**Type I Administrative Hearing
Findings and Decision
on August 6, 2024**

FINDINGS AND DECISION

PROJECT NAME: College and Trilby Multifamily

CASE NUMBER: PDP # 220009

Modification to Standard to LUC § 3.5.2(C)(2)(a)
Affected Regions

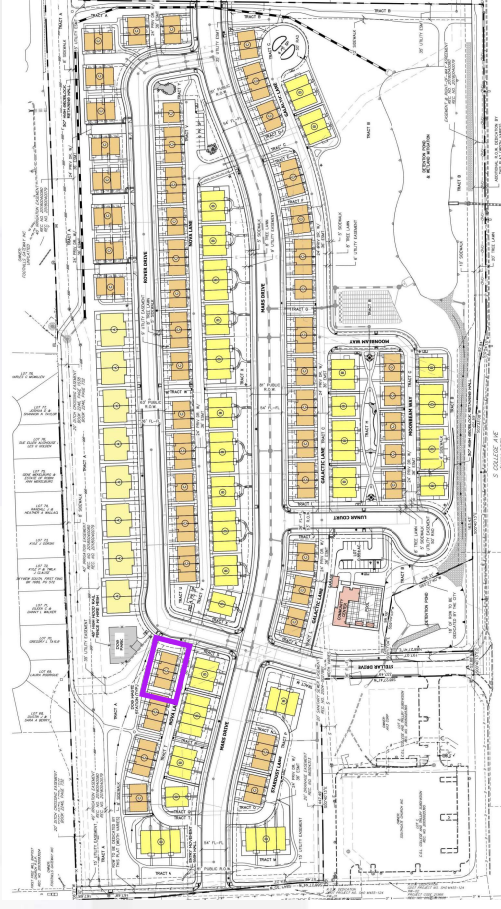
- C. The Modification of Standard to LUC § 3.5.2(C)(2)(a) to allow buildings with duplicate footprints to be placed next to each other in the six regions of the Subject Property shown on ATTACHMENT A to this decision (the "**Affected Regions**"): (i) will not be detrimental to the public good, (ii) will promote the general purpose of subsection 3.5.2(C)(2)(a) equally well or better than would a plan which complies with the standard, and (iii) will not diverge from subsection 3.5.2(C)(2)(a) except in a nominal, inconsequential way when considered from the perspective of the entire PDP and will continue to advance the purposes in LUC § 1.2.2. With respect to the foregoing, the Hearing Officer specifically incorporates the Staff Findings on page 7 of the Staff Report and finds:

- ii. The exterior designs of the buildings located next to each other in the Affected Regions are different to a degree that promotes variety and visual interest for pedestrians and other passers-by.

- iii. Based on the Applicant's testimony and presentation materials at the public hearing (*see* Item No. 16 in the Evidence list above), the Project includes significant variations in its buildings' design and exterior appearance. The Project includes three types of townhomes (two of which have different unit counts), three elevation styles

(Traditional, Transitional, and Scandinavian), and four color schemes. The foregoing design features result in twenty-eight different architectural variations.

- iv. Based on the Applicant's testimony and presentation materials, including ATTACHMENT A to this decision, visually identical buildings will not be placed next to each other within the Affected Regions.

Only six regions on the site that duplicate footprints side by side.

1. The buildings affected by the approved Modifications of Standards shall be identified on the site plan for the PDP and the site plan for the final development plan ("**FDP**") for the Project consistent with what is shown on ATTACHMENTS A and B to this decision. Notes explaining these modifications shall be included on the site plans for the PDP and FDP.

3. The Applicant shall revise the PDP site plan and architectural plan sheets to more clearly articulate the different building types, elevation types, and color schemes included in the Project, and shall include in the PDP plan documents where these design features will be distributed throughout the Subject Property. These required revisions shall be done in a manner that is satisfactory to City staff but shall be generally consistent with ATTACHMENTS A and B to this decision.

Modification of a Standard for Street-Facing Facades – 3.5.2(D)(2)

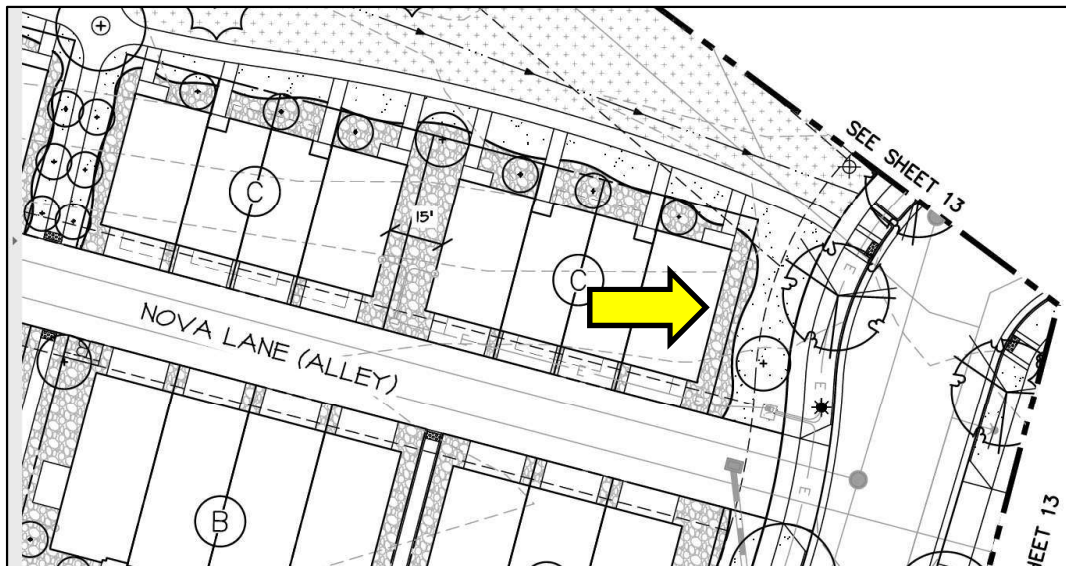
This is one such occurrence out of 85 buildings. The interior of the building is a garage partly below grade, with the grade in the outside yard sloping down along the building wall such that a doorway would be non-functional. The visual impact is mitigated by being located on a curve, and by two trees in the foreground closer to the sidewalk.

This one occurrence out of 85 buildings has virtually no effect on the look and feel of this 38-acre plan when considered from the perspective of the entire plan.

Criterion (4), "nominal and inconsequential". From the perspective of the entire development plan, the one end of one building facing Rover Drive without a doorway is nominal and inconsequential for reasons stated above and does not affect the purposes of the Land Use Code.

Staff finds that the granting of the modification would not be detrimental to the public good and that the plan satisfies criteria in subparagraph (4), "nominal and inconsequential" under Section 2.8.2(H) governing modification requests.
